IA-32 Intel® Architecture Software Developer's Manual

Documentation Changes

December 2002

Document Number: 252046

Figure 8-10. Real Mode x87 FPU State Image in Memory, 32-Bit Format

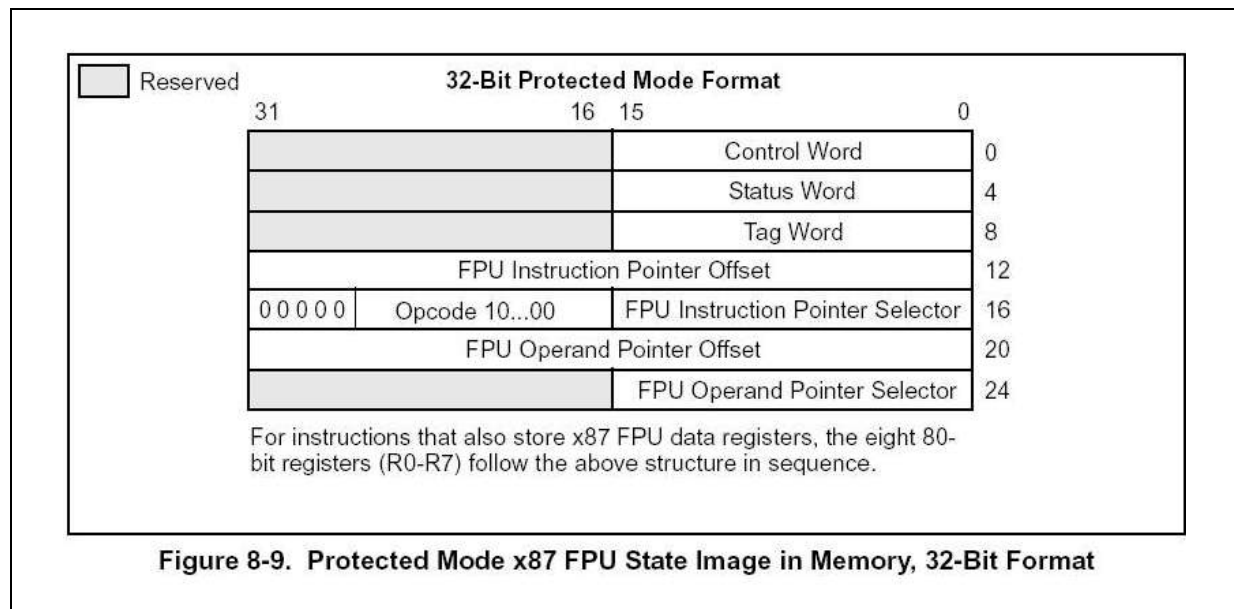
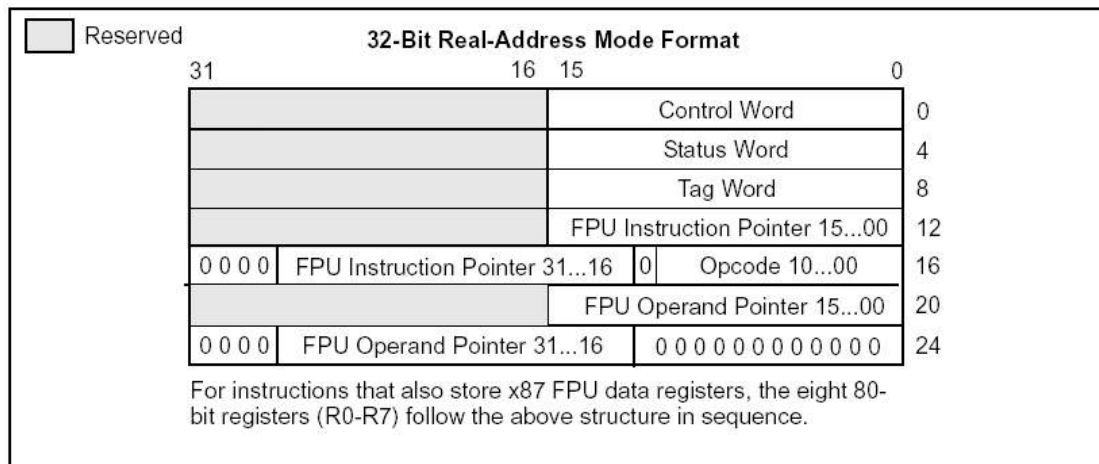
In the *IA-32 Intel® Architecture Software Developer's Manual, Volume 1: Basic Architecture*, Chapter 8, Figures 8-9 and 8-10 have been updated to include a short note about storage of the X87 data registers during the operation of FSAVE. Both updated figures are shown below:
